## MONITORING YEAR 3

### MOORES FORK STREAM MITIGATION PROJECT

Wildlands Engineering, Inc. (Wildlands) has reviewed the Division of Mitigation Services (DMS) comments from the Draft Monitoring Year 3 report for the Moores Fork Stream Mitigation Project. The following Wildlands responses to DMS's report comments are noted in italics lettering.

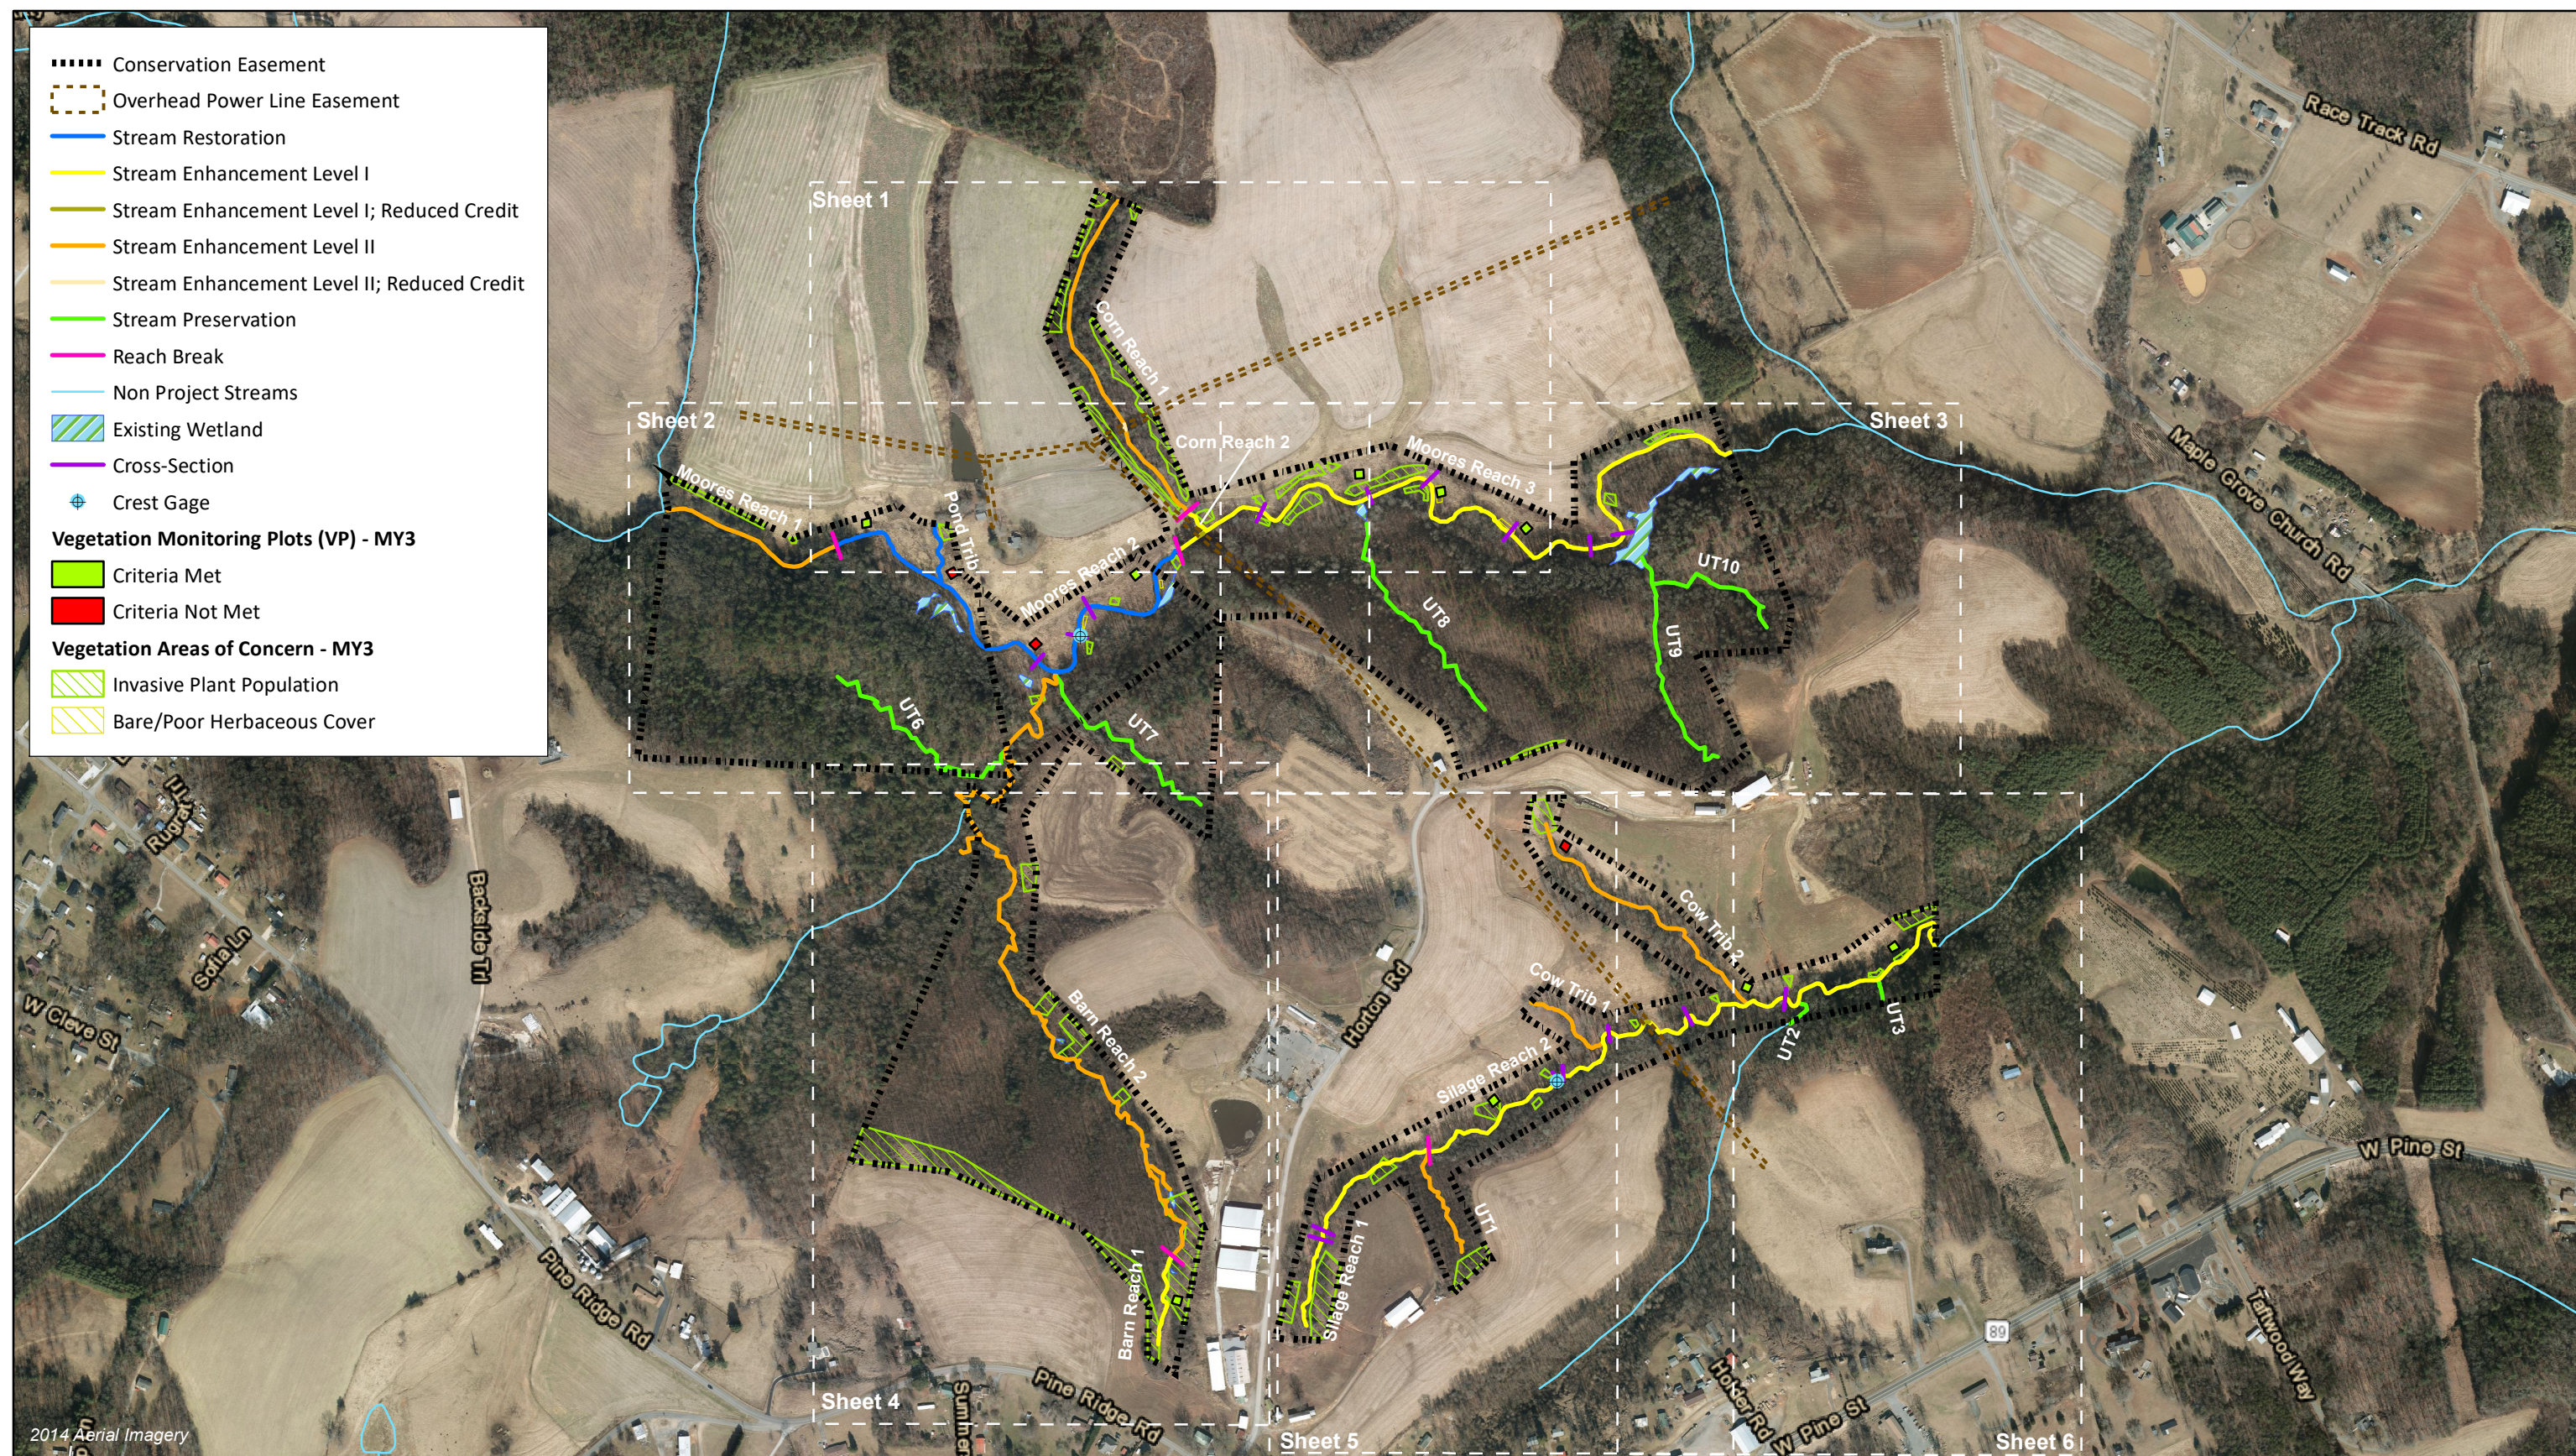
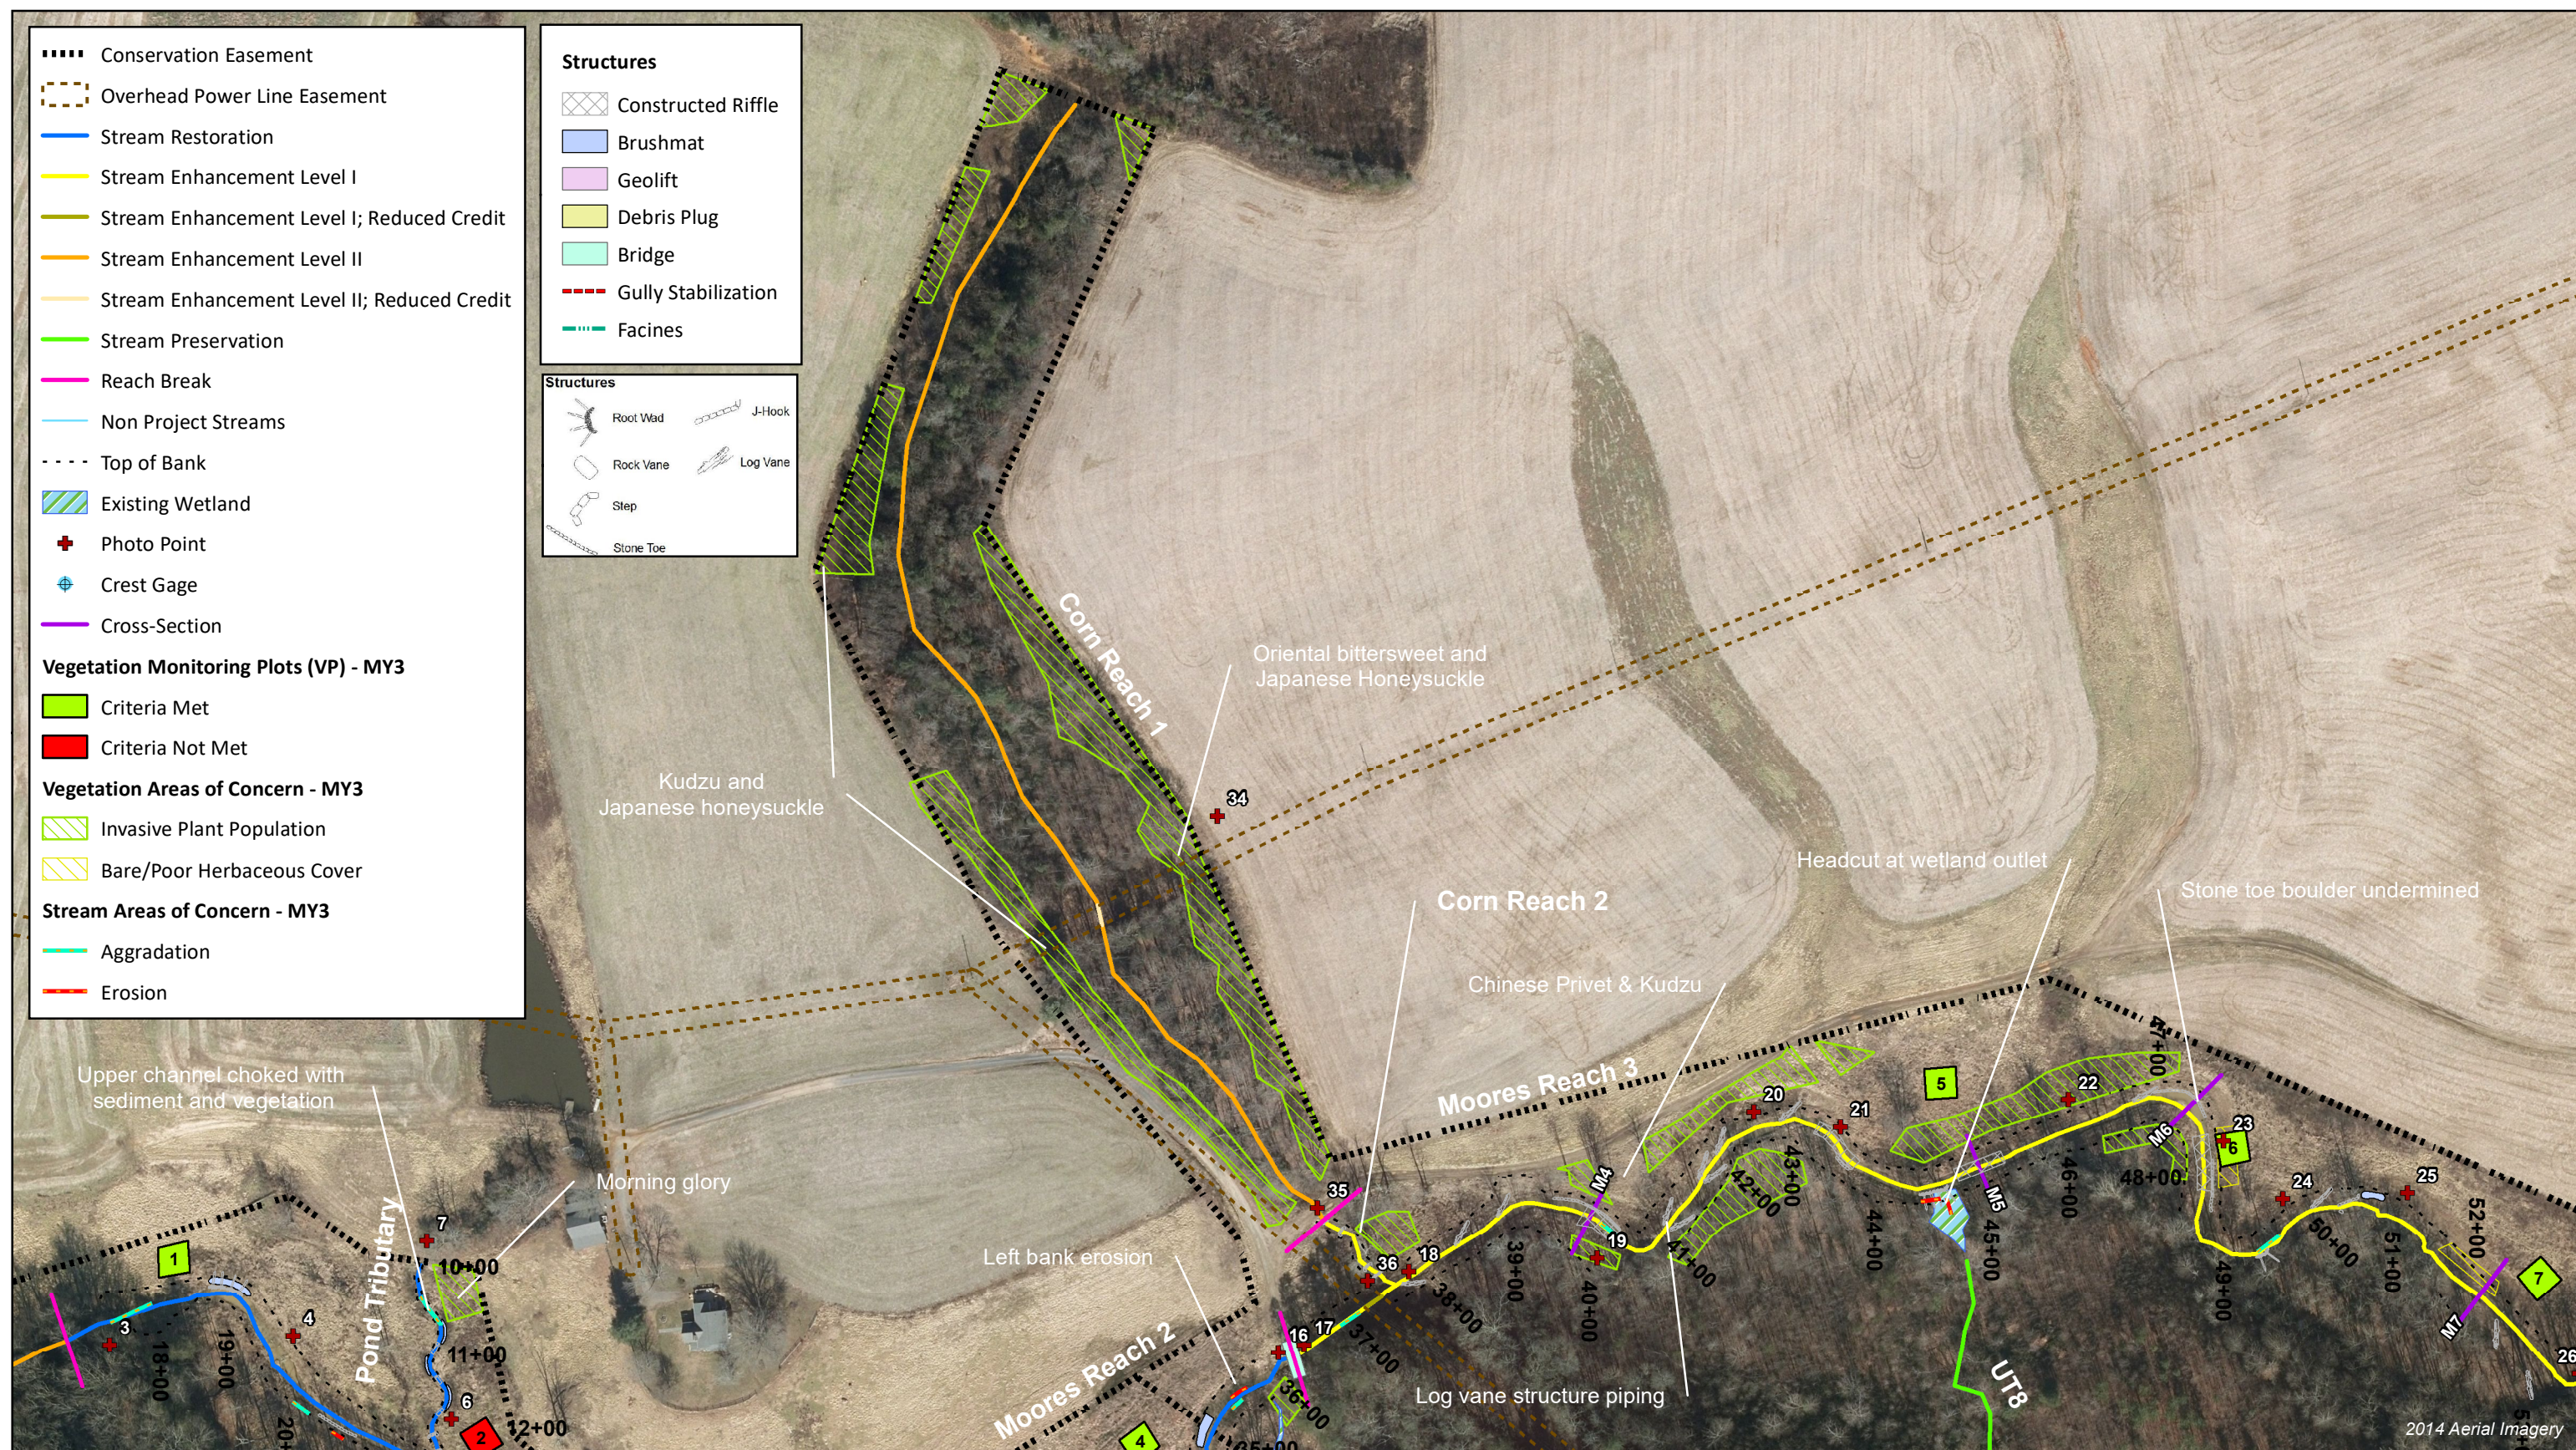
**DMS comment; CCPV: Thanks for providing updated invasive species polygons. Please continue to update as treatment occurs and populations are reduced. This map is a useful tool for the contractor treating the site.**

**DMS comment; CCPV: Please update map with the two additional utility lines.**

**DMS comment; DMS made a site visit on November 26, 2018. We are exploring the possibility of remedial action to some areas depicted on the CCPV as being problem areas. DMS will coordinate with Wildlands when final decisions have been made.**

*Wildlands response; Wildlands will continue to update the CCPV figures as treatment of invasive species occurs and populations are reduced.*

*Wildlands response; The CCPV figures have been updated with the additional utility lines crossing on Moores Fork and Corn Trib.*

*Wildlands response; Thank you for this information. Wildlands will look for communication from DMS about possible remedial action to some areas of concern depicted on the CCPV.*
